June 14, 2021

## **Addendum No. 1:**

### **Project: PSFA PROJECT NO: P19-009 – Mesa Middle School Renovations and Addition – Roswell Independent School District and PSFA**

**A2 PHASING PLAN - PHASE 3 DEMOLITION**  
NTS

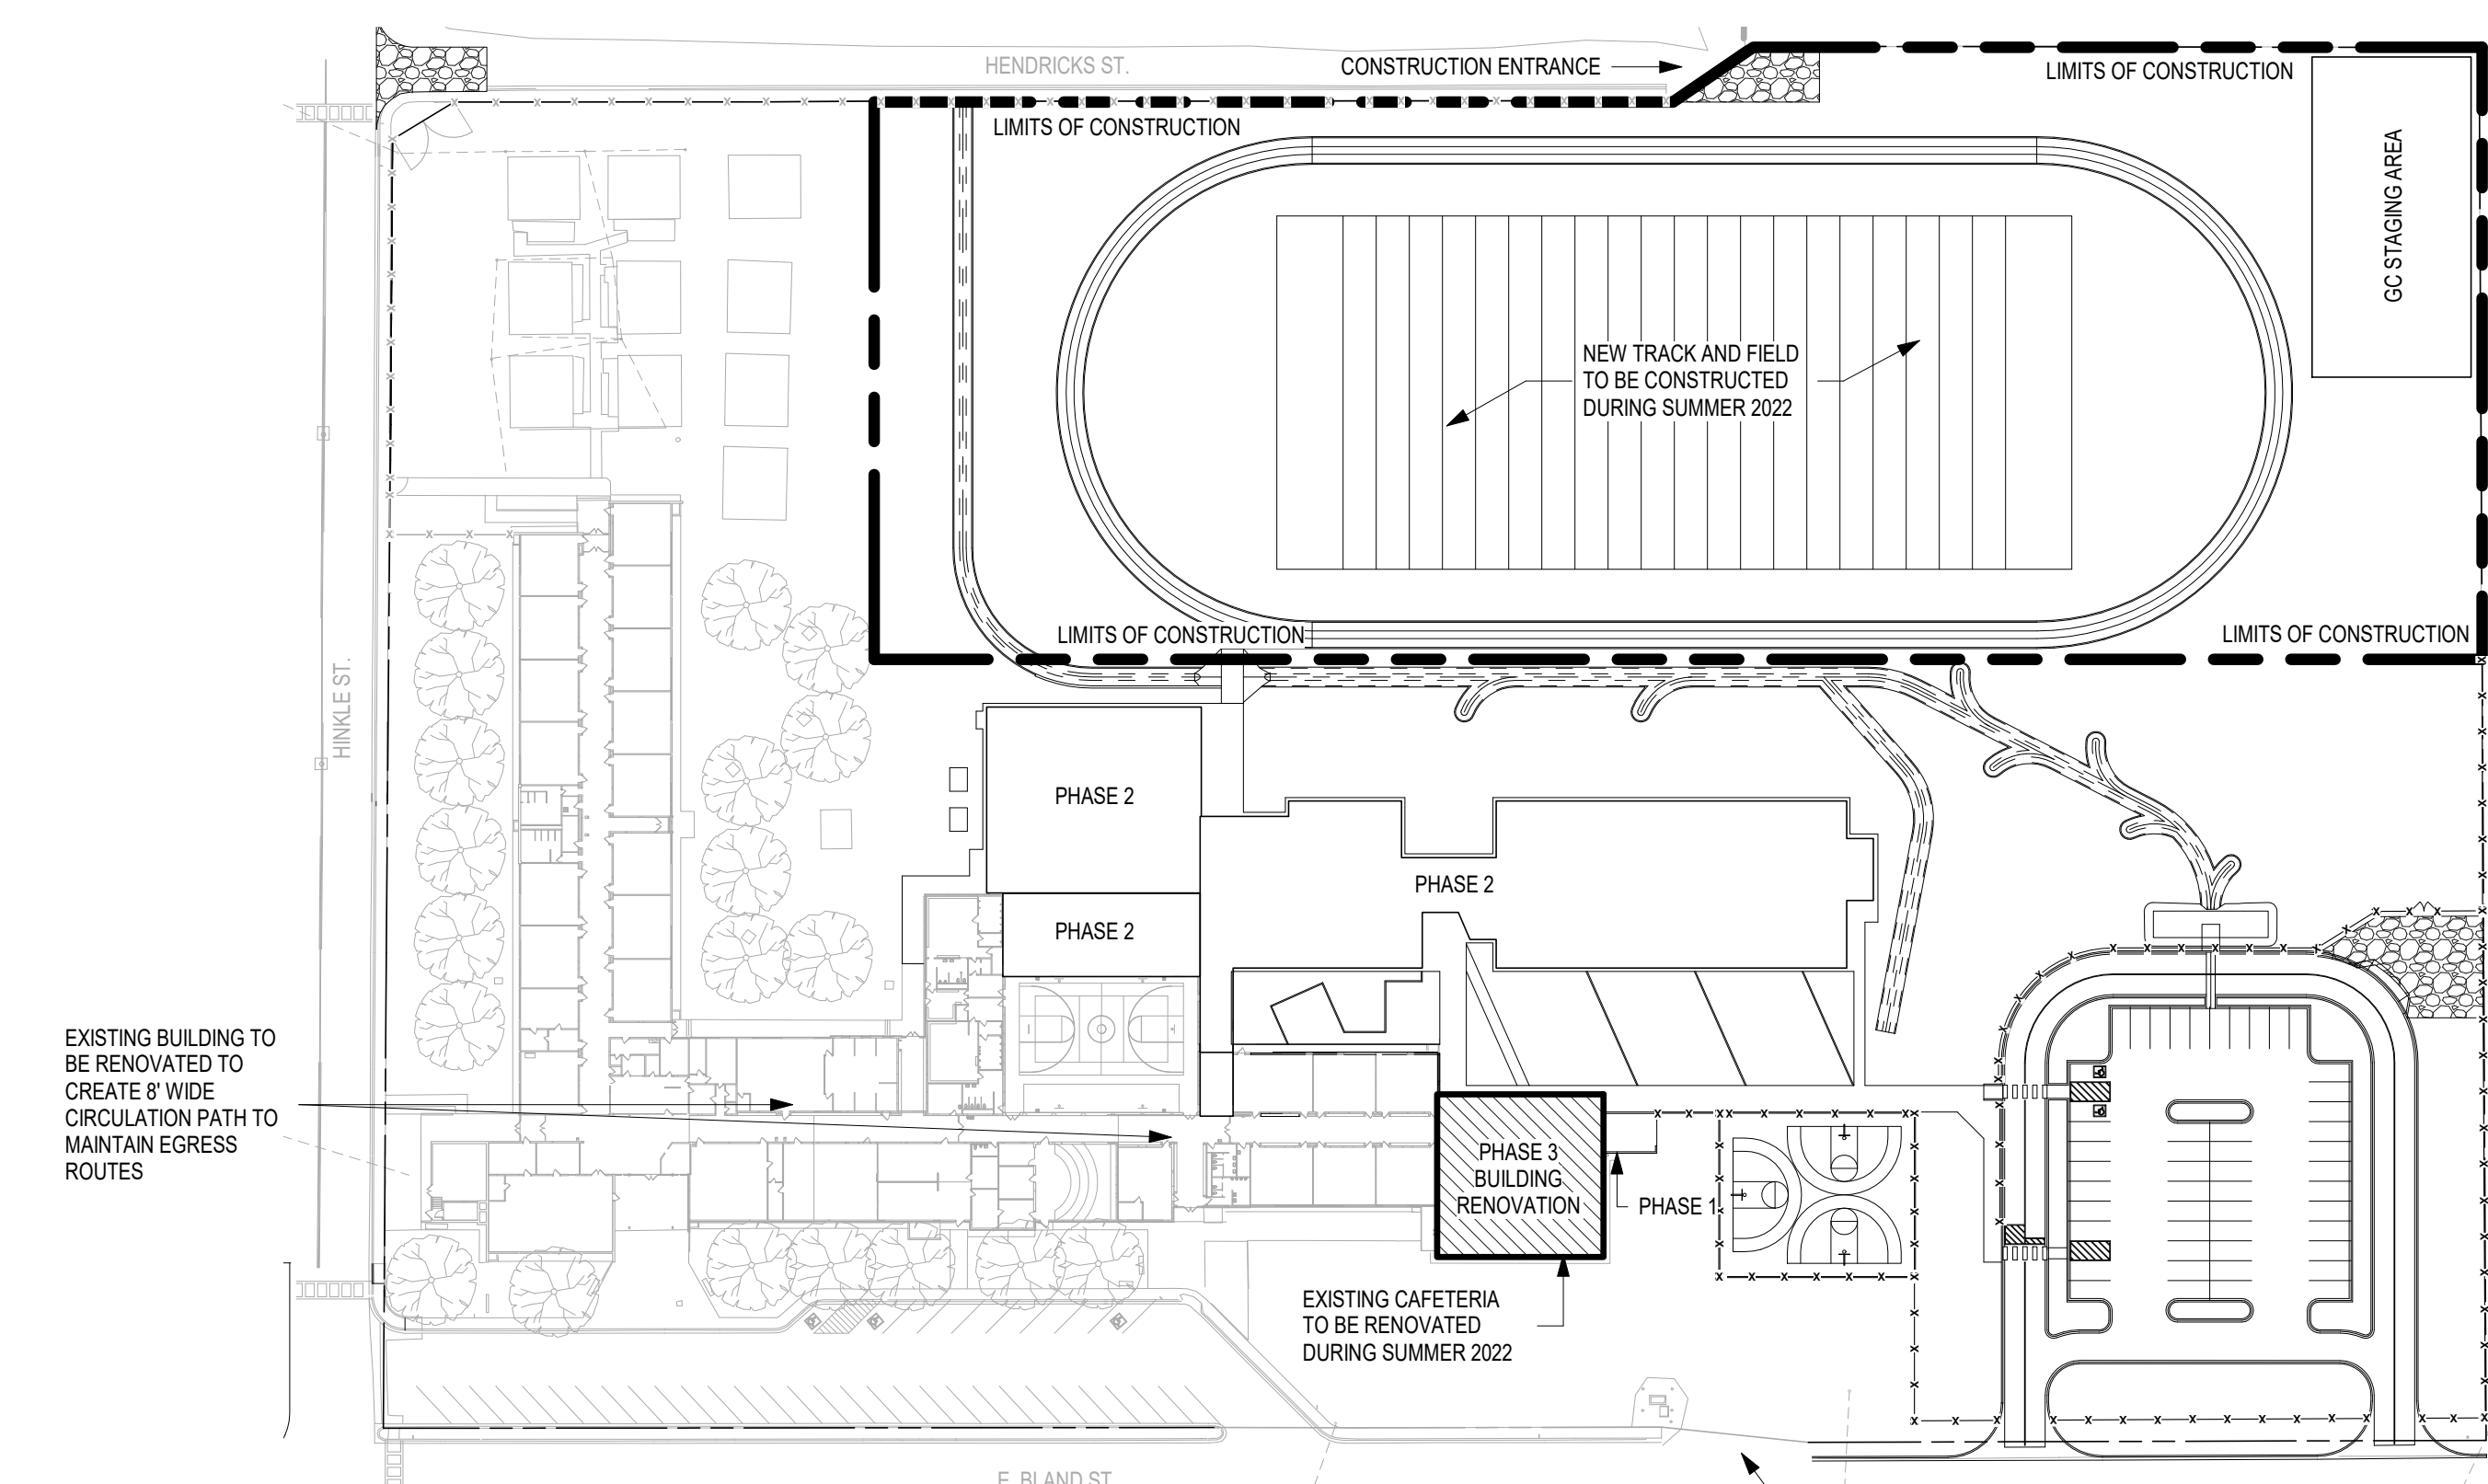
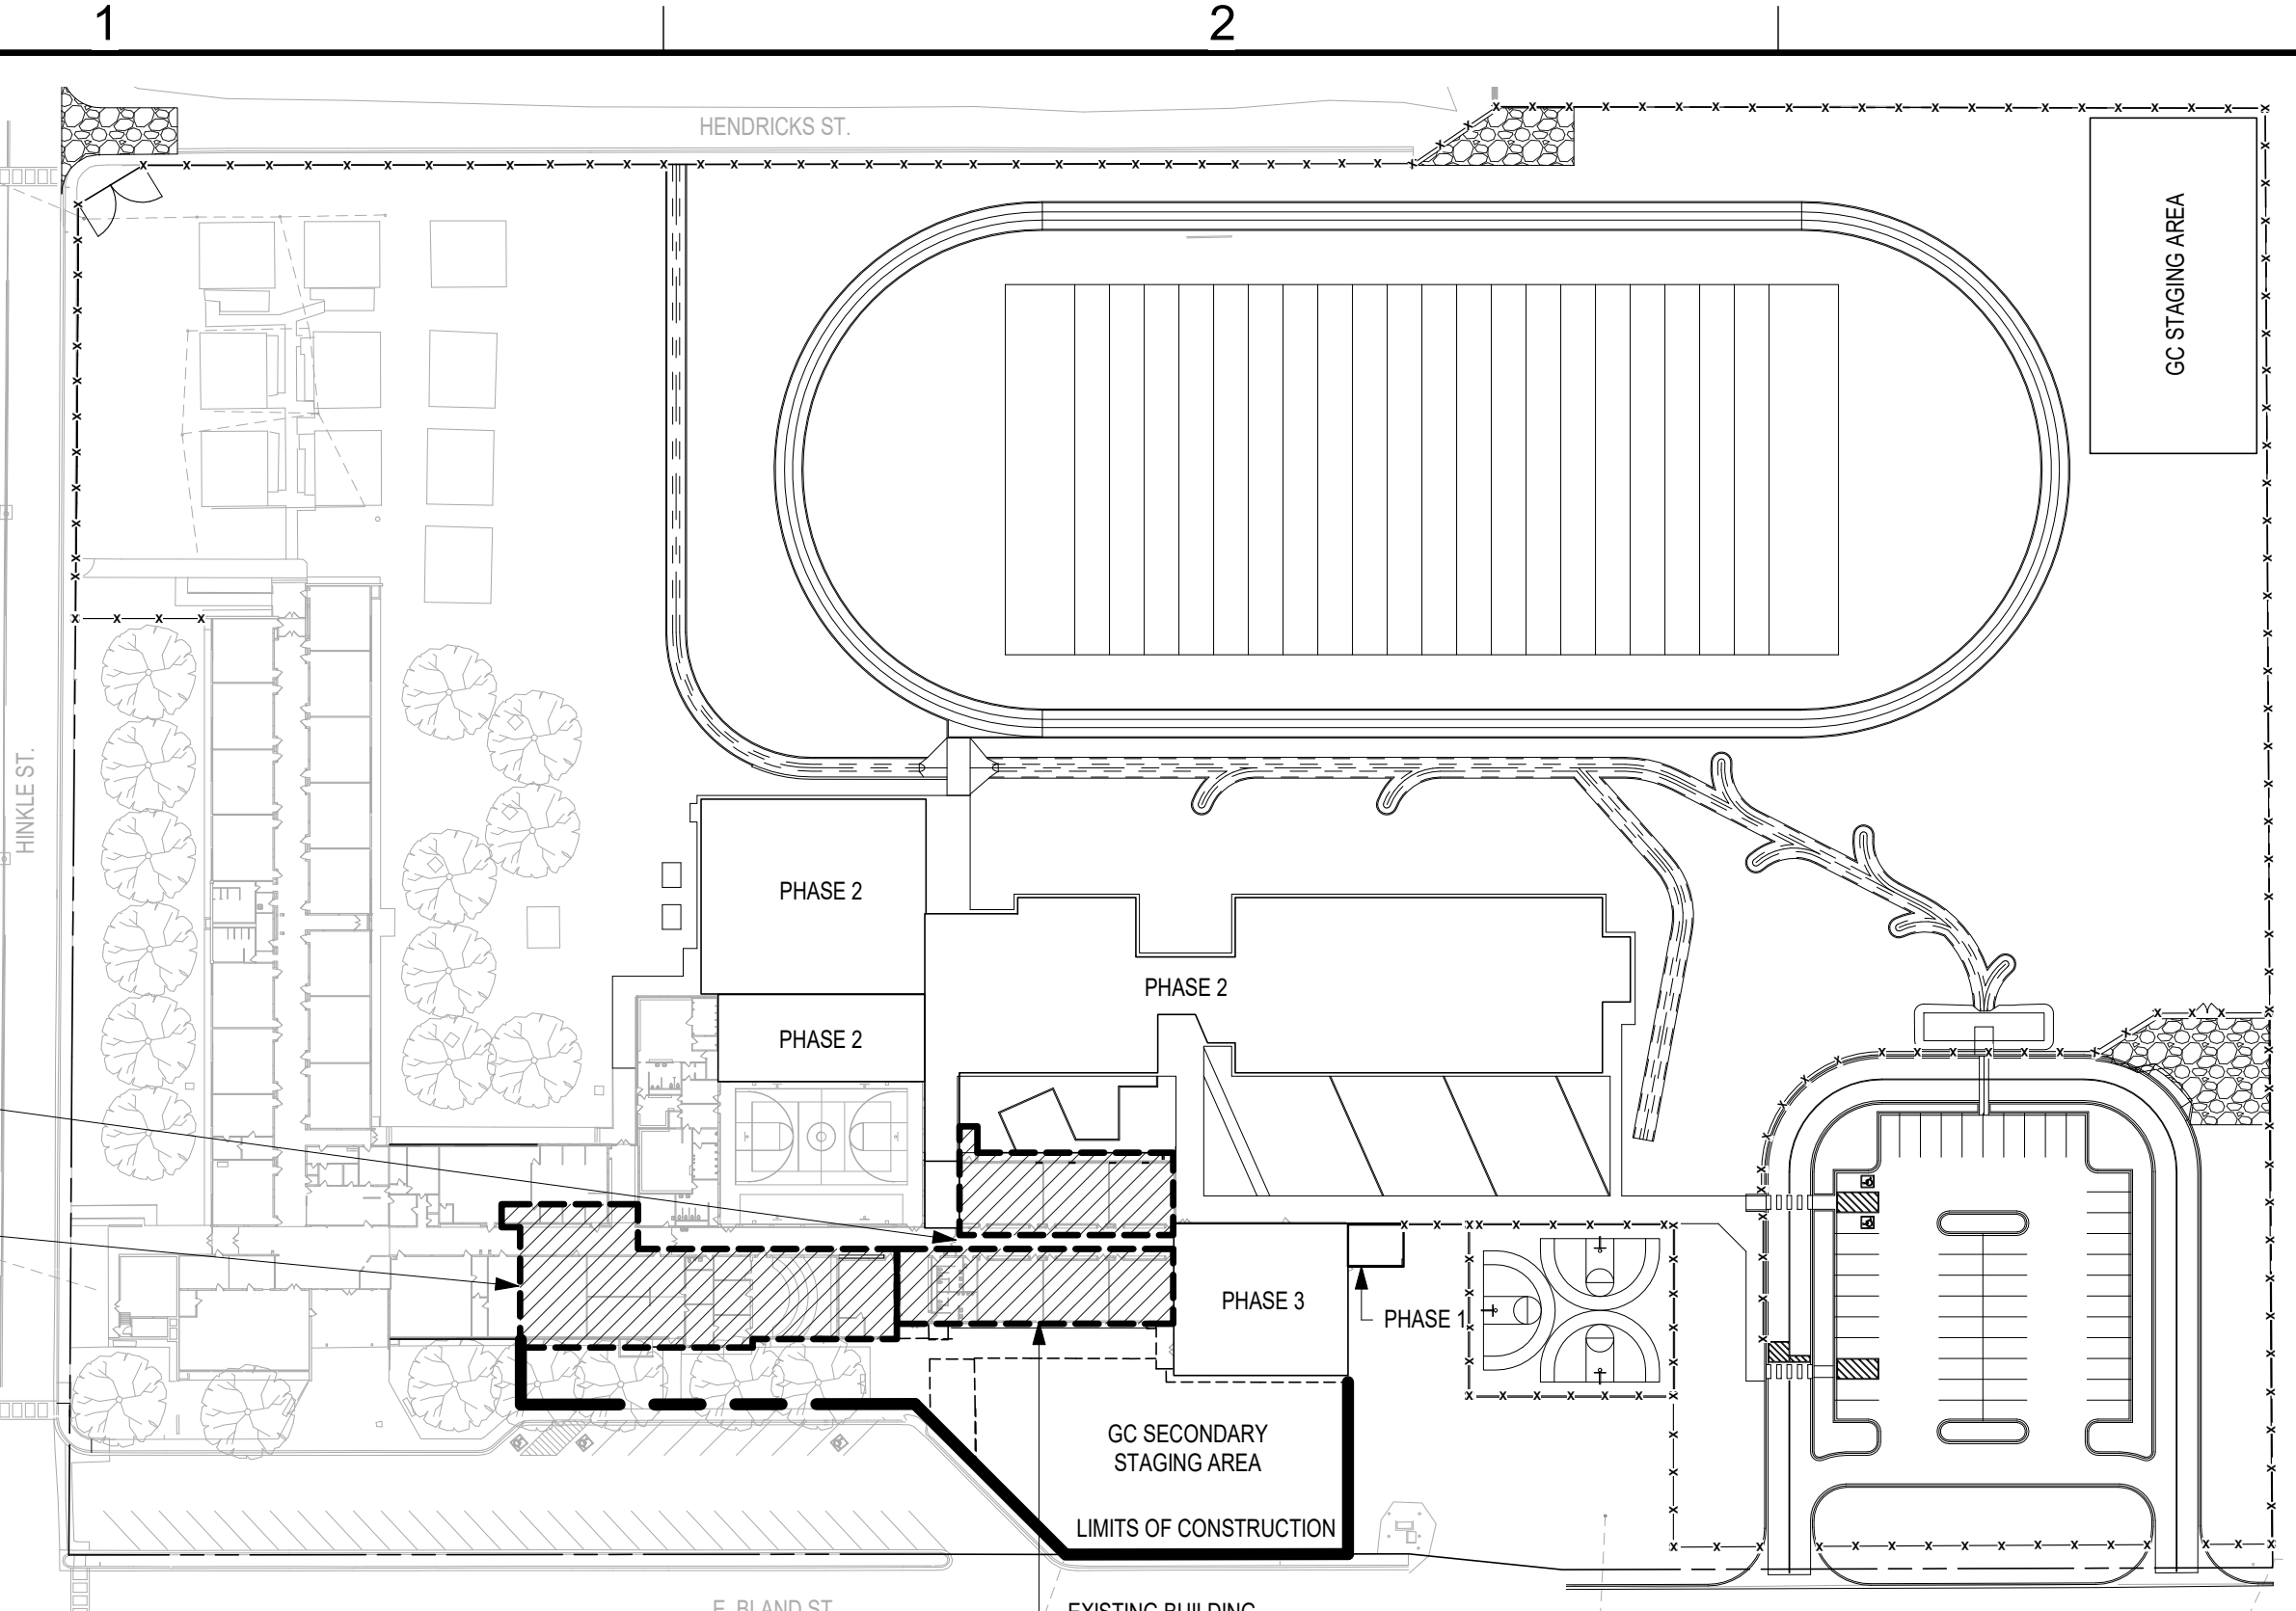
10. *G-005 specifies "Existing Cafeteria to be renovated during summer." Keeping in mind the anticipated award date of July 14, what is the deadline for completion of this portion of work?*

17. *Phasing Plan B2 "Phase 2 Demolition" indicates "corridor to remain accessible to students." Will this corridor need to remain open throughout construction?*
  - a. **Yes, path to cafeteria to remain open during construction.**
18. *How long will it take to relocate the school program to portables before Phase 2A commences?*
  - a. **No Phase 2A shown on Sheet G-005. Clarify question.**

- a. **See updated G-005 and G-005A Phasing Plans in this Addendum.**
11. *Is the General Contractor responsible for the abatement of existing facilities?*
